## STAFF RECOMMENDATION 1211 Paris Avenue August 15, 2012

**Application:** New construction - additions  
**District:** Belmont-Hillsboro Neighborhood Conservation Zoning Overlay  
**Council District:** 18  
**Map and Parcel Number:** 11801007700  
**Applicant:** Nick Dryden, Architect  
**Project Lead:** Sean Alexander, sean.alexander@nashville.gov

<p><b>Description of Project:</b> The applicant is proposing to construct a ridge raise addition, a rear dormer addition, and to enclose an existing rear corner porch. The upperstory additions will set in from the sides of the existing house by two feet (2') and will increase the height by two feet (2'). The additions will be clad with smooth cement-fiber siding matching the exposure of the existing siding. The additions will also have a fiberglass-asphalt shingles and wood windows.</p>	<p><b>Attachments</b> <b>A:</b> Photographs <b>B:</b> Site Plan <b>D:</b> Elevations</p>
<p><b>Recommendation Summary:</b> Staff recommends approval of the ridge raise, rear dormer addition, and rear porch enclosure, finding the proposal to meet the applicable sections of the Belmont-Hillsboro Neighborhood Conservation Zoning Overlay design guidelines.

1211 Paris Avenue, left side. Existing partially-enclosed rear corner porch can be seen.

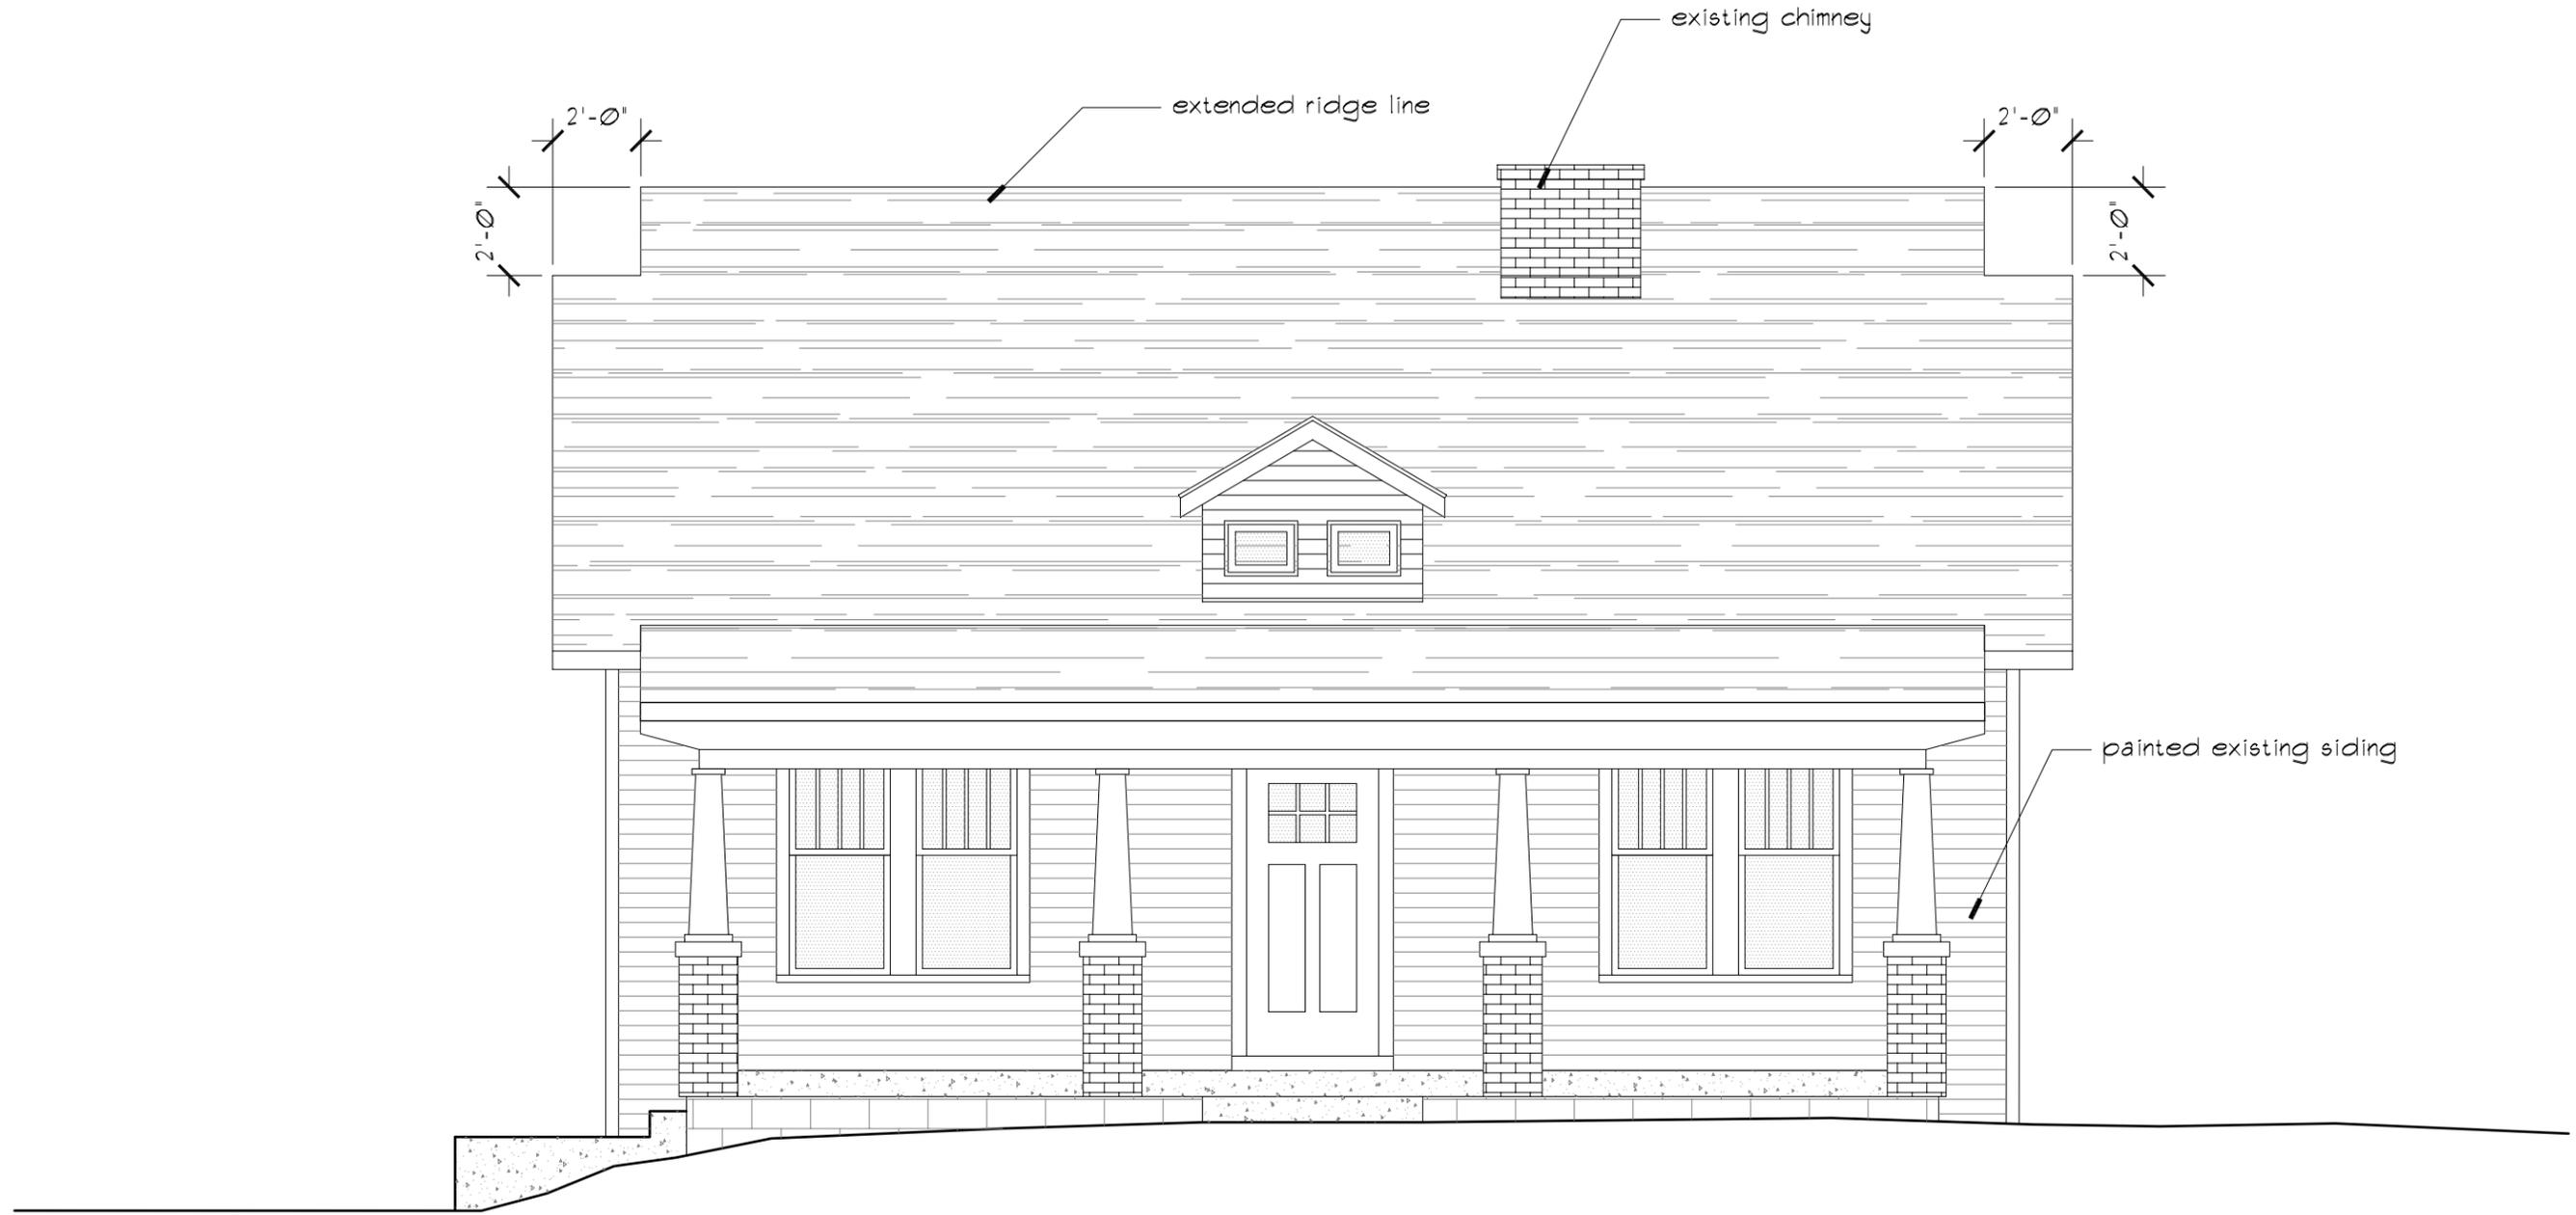
The existing rear corner porch will also be enclosed. The footprint of the house will not be changed. This porch has already been modified and no longer retains its original appearance, so further enclosure does not conflict with guidelines II.B.2.a. and II.B.2.c.

**Recommendation:** Staff recommends approval of the ridge raise, rear dormer addition, and rear porch enclosure, finding the proposal to meet the applicable sections of the Belmont-Hillsboro Neighborhood Conservation Zoning Overlay design guidelines.
